## 113372 - 00

**Change Notification #:** 113372-00  
**Change Title:** Intel® Compute Module HNS2600JF  
PCN 113372-00, Product Design  
Change the material of tray latch cap from  
rubber to polycarbonate  
**Date of Publication:** November 4, 2014

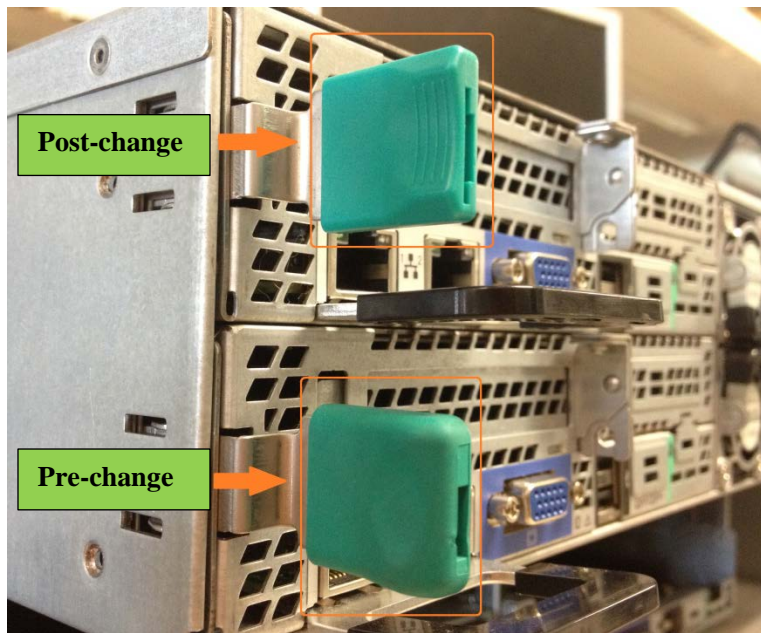
Change the material of tray latch cap from rubber to polycarbonate to avoid pulling the cap out from the tray latch.

See below picture: the lower one is pre-change cap and the upper one is post-change cap.
